SUBJECT: Requests relief from exam coverage requirements of ASME  
 Section XI for five welds identified in relief requests  
 SR-14 through SR-17.

**VIRGINIA ELECTRIC AND POWER COMPANY**  
**SURRY POWER STATION UNIT 2**  
**INSERVICE INSPECTION PROGRAM**  
**EXAMINATION RELIEF REQUESTS**

Weld Examination Partial Coverage Relief Requests

SR-14 through SR-17

Figure SR-14-1

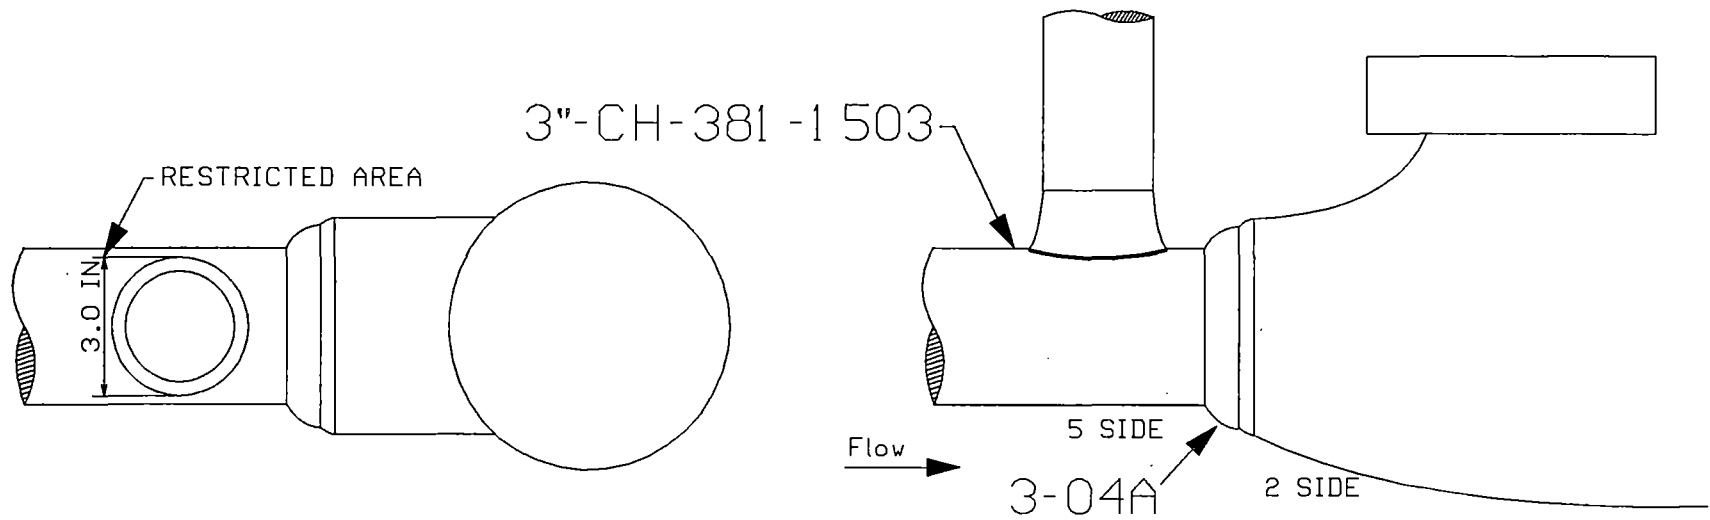
The component listed is a three inch pipe to valve body weld. This weld is located on the upstream side of the discharge check valve for the "A" charging pump. The component listed above has been examined to the extent practical as required by the Code. Due to interferences from a branch connection and an adjacent valve body the reduction in coverage of the volumetric examination is detailed in Table SR-14-1. The required surface examination had no limitations. Figure SR-14-1 is provided detailing the limitations experienced.

<u>Mark/Weld#</u>	<u>UT Scan Coverage %</u>				<u>Surface Examination Coverage %</u>	<u>Reason For Partial</u>
	<u>2</u>	<u>5</u>	<u>7</u>	<u>8</u>		
3-04A	73	73	100	100	100	A branch connection limits the 2 and 5 scan to 8 out of 11 inches. A valve body limits the examination to one side. The 2 scan was performed using an extended beam.

It is proposed that the examination completed at the reduced coverage be counted as meeting the Code preservice requirements.

FIGURE SR-15-1

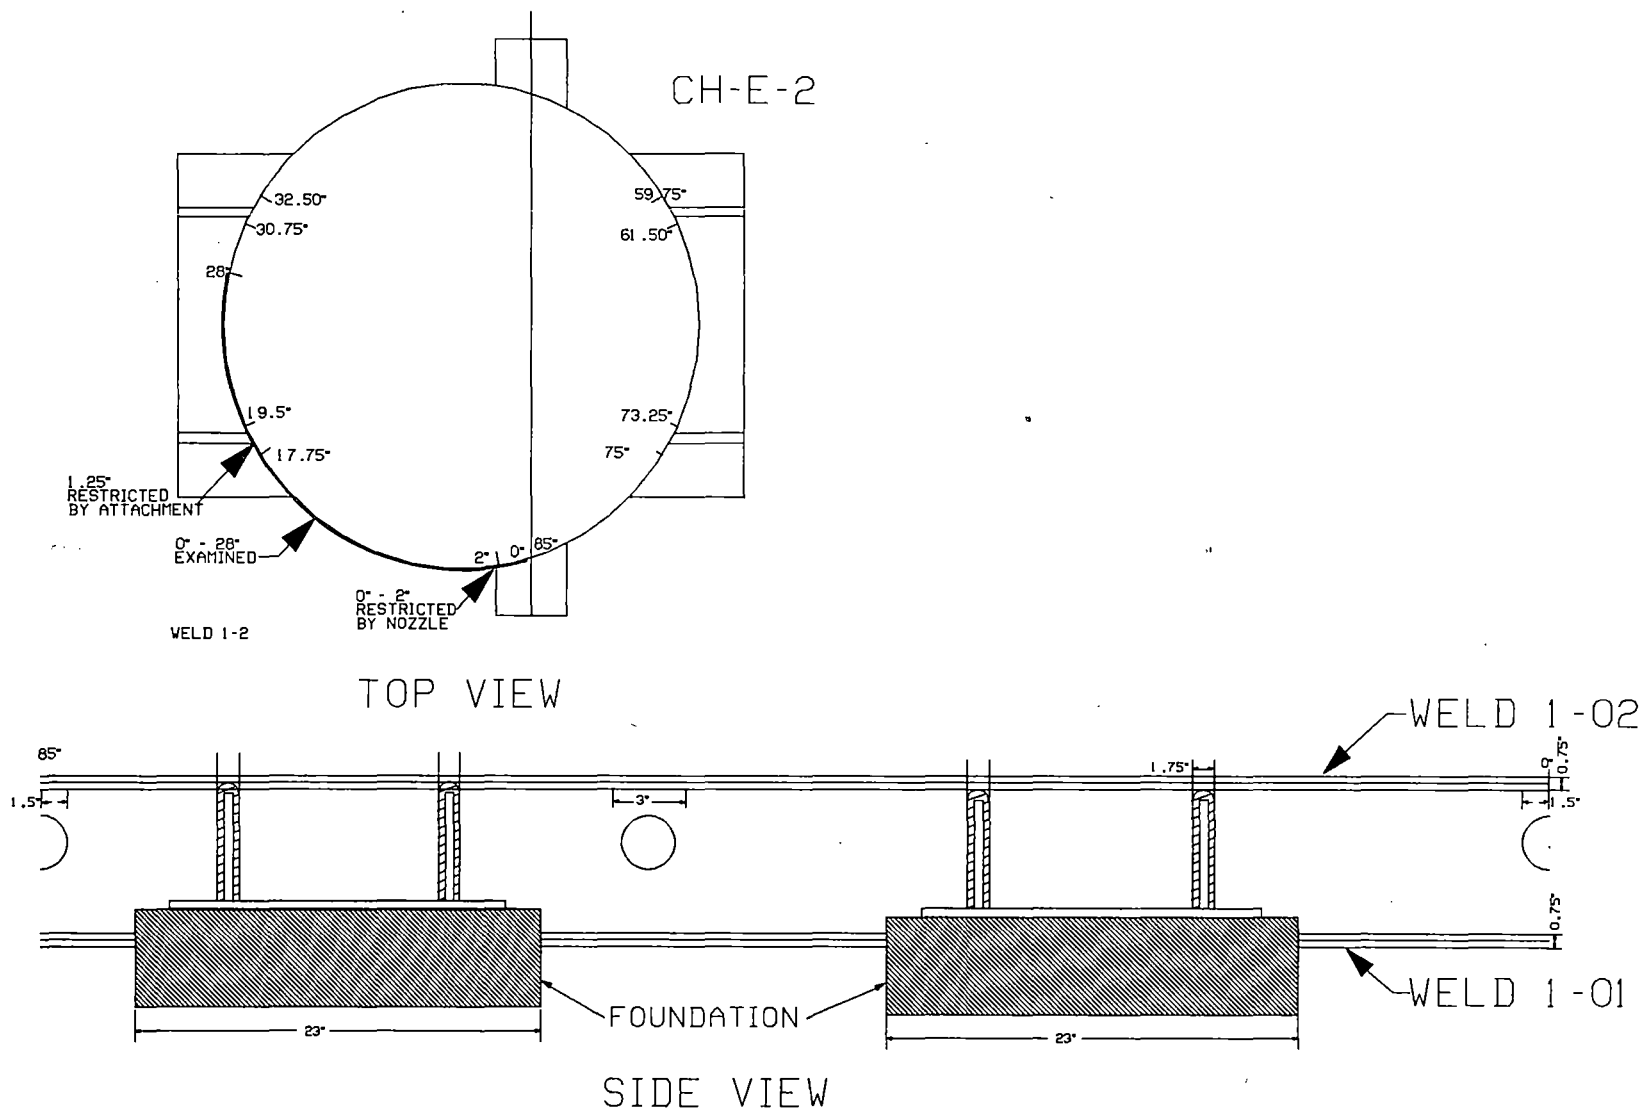
One third of the welds listed above have been examined to the extent practical as required by the Code. The examinations were limited due to interferences from the non-regenerative heat exchanger inlet nozzle and a component support. Similar restrictions are expected for the remaining two thirds. The anticipated reduction in coverage of the volumetric examination is detailed in Table SR-15-1. Figure SR-15-1 is provided detailing the limitations experienced.

Mark/Weld#	UT Scan Coverage %				Section XI Item Number	Reason For Partial
	2	5	7	8		
Completed Examinations 0" to 28"						
1-01	93.75	93.75	50	50	C1.20	A component support limits the 7 and 8 scan to 14 inches out of 28 inches (0 inches to 14 inches). An extended beam path was used for the 2 and 5 scans.
1-02	88.39	88.39	100	100	C1.10	A 3 inch OD inlet nozzle 0.6 inches from the toe of weld, a welded support between 17.75 inches and 19.5 inches, the 5 side of the weld is flanged with studs and nuts blocking access.
Scheduled Examinations 28" to 85"						
1-01	93.75	93.75	44	44	C1.20	Two component supports limit the 7 and 8 scans to 25 out of 57 inches. An extended beam path will be used for the 2 and 5 scans.
1-02	84.7	84.7	100	100	C1.10	The 2 and 5 scans will be restricted by two 3 inch OD nozzles 0.6 inches from the toe of weld, three welded supports restricting 1.25 inches. The 5 side of the weld is flanged with studs and nuts blocking access. Extended beam path will be used.

It is proposed that the examinations completed at the reduced coverage and scheduled examinations at the coverage stated in Table SR-15-1 be counted as meeting the Code requirements.

Figure SR-16-1

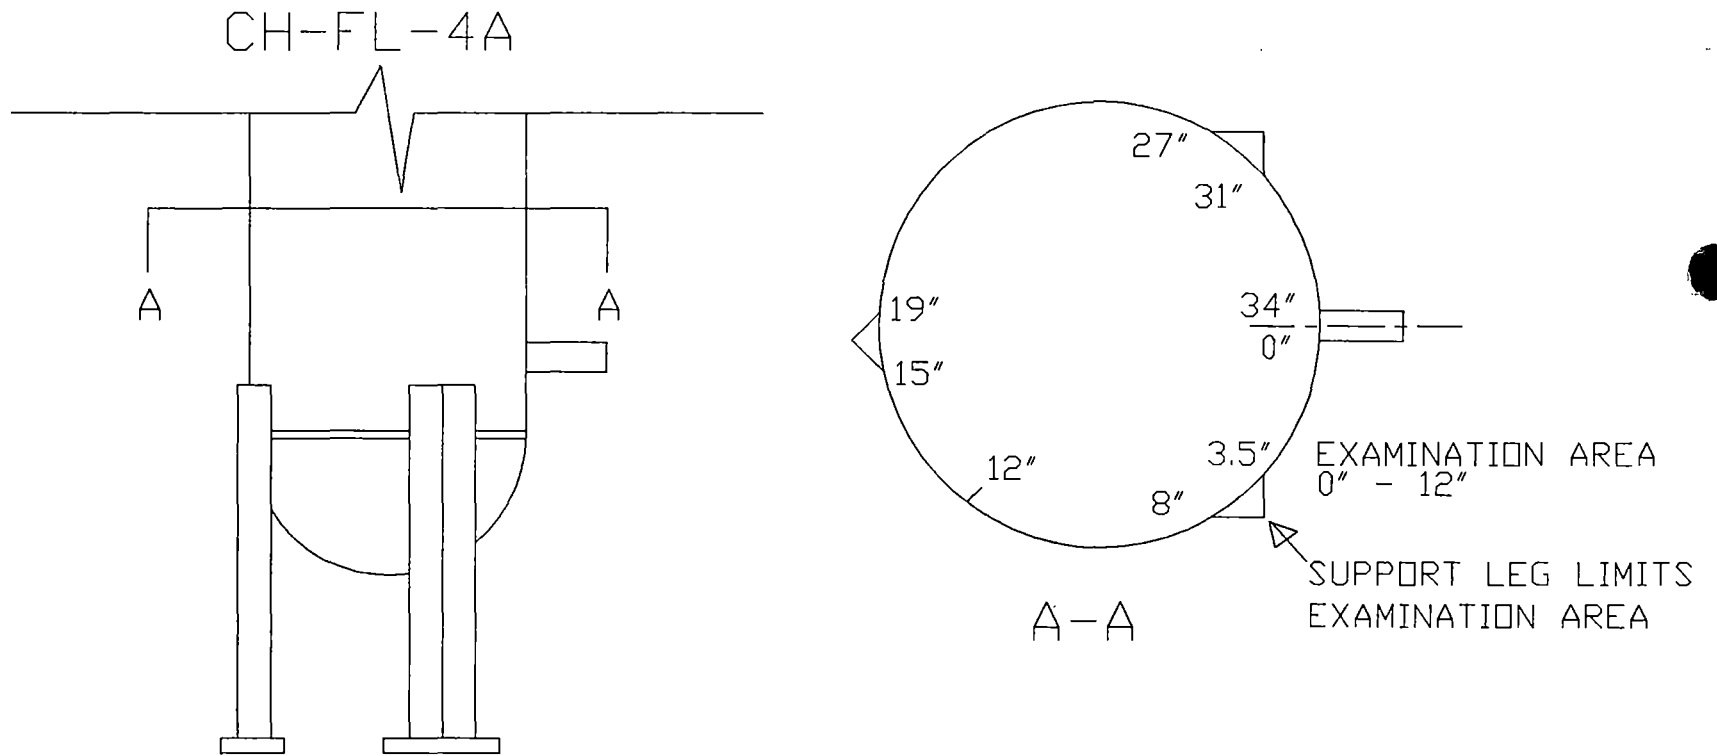
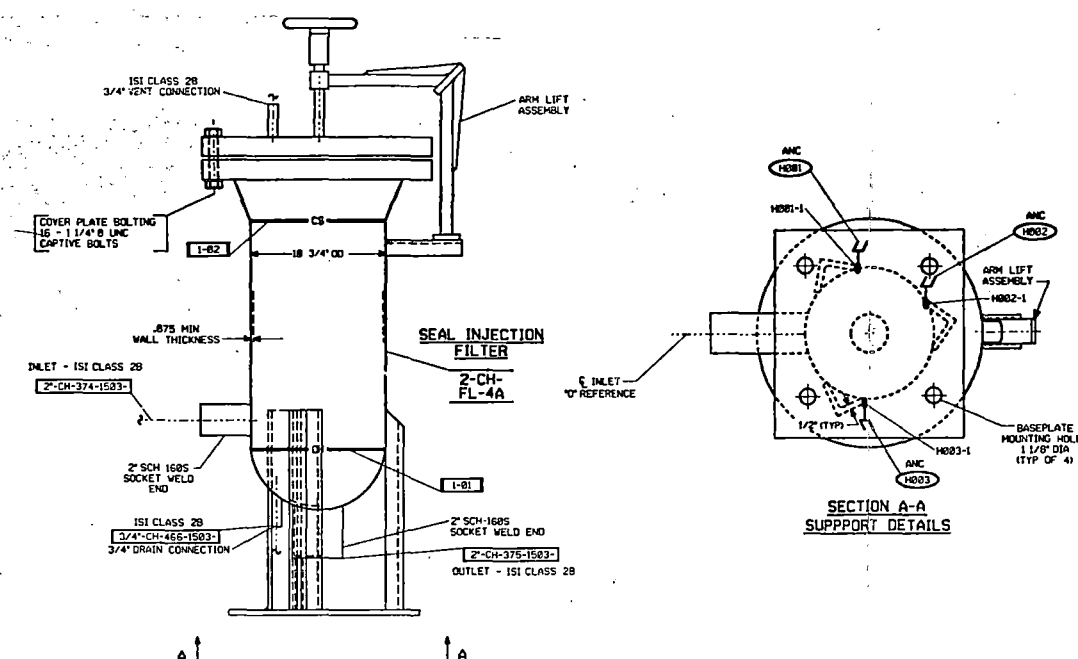
The component listed above is the lower head to shell weld of the "A" seal water injection filter. One third, 0" to 12", of the component listed above has been examined to the extent practical as required by the Code. Due to interferences from a support leg the reduction in coverage of the volumetric examination is detailed in Table SR-16-1. Figure SR-16-1 is provided detailing the limitations experienced. Interferences were encountered when the remaining two thirds of the weld was examined during the second interval. It is anticipated that the same limitations will exist when the remaining two thirds of the weld are examined during the third inspection interval.

<u>Mark/Weld#</u>	<u>Beam Angle</u>	<u>Exam Area</u>	<u>Scan Direction</u>	<u>% Exam</u>	<u>Reason For Partial</u>
1-01 (0" - 12")	45	Weld	2	62	Support leg
	45	Weld	5	62	
	45	Weld	7	82	
	45	Weld	8	82	
	45	Base	2	62	
	45	Base	5	60	
	45	Base	7	82	
	45	Base	8	82

It is proposed that the examination completed at the reduced coverage be counted as meeting the Code requirements. The remaining two thirds will be examined to the extent practical. The estimated coverage is for the remaining two thirds is expected to be similar to the coverage presented in Table SR-16-1.

FIGURE SR-17-1

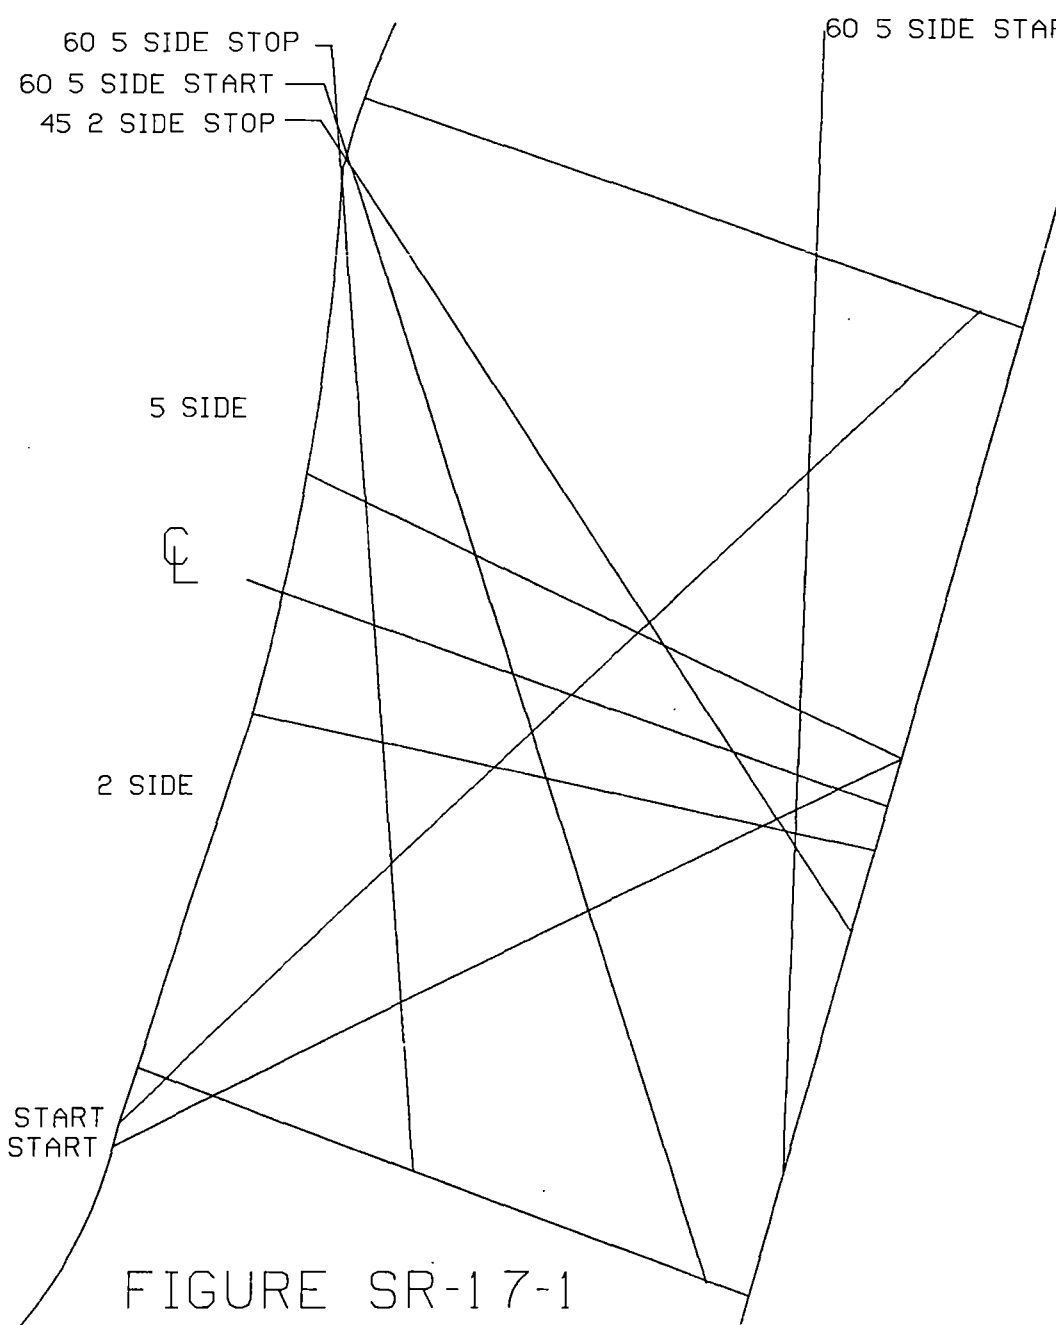
The component listed above is the reactor head to flange weld. One third, 0" to 179", of the component listed above has been examined to the extent practical as required by the Code. Due to interferences from a lifting lug and the geometry of the weld the reduction in coverage of the volumetric examination is detailed in Table SR-17-1. Figures SR-17-1 and SR-17-2 are provided detailing the limitations experienced. The surface examination had no limitations.

<u>Mark/Weld#</u>	<u>Beam Angle</u>	<u>Exam Area</u>	<u>Scan Direction</u>	<u>% Exam</u>	<u>Reason For Partial</u>
1 (0" - 179")	0	Weld & Base	-	96.65	Joint Configuration and Lifting Lug
	45	Weld	2	91.84	
	45	Weld	5	96.65	
	45	Weld	7	96.65	
	45	Weld	8	96.65	
	60	Weld	2	56.71	
	60	Weld	5	90.16	
	60	Weld	7	96.65	
	60	Weld	8	96.65	
	45	Base	2	70.96	
	45	Base	5	96.65	
	45	Base	7	95.19	
	45	Base	8	95.19	
	60	Base	2	44.23	
	60	Base	5	83.02	
	60	Base	7	94.86	
	60	Base	8	94.86

It is proposed that the examination completed at the reduced coverage be counted as meeting the Code requirements. The remaining two thirds will be examined to the extent practical. The estimated coverage for the remaining two thirds is expected to be similar to the coverage presented in Table SR-17-1 for 0" to 179".
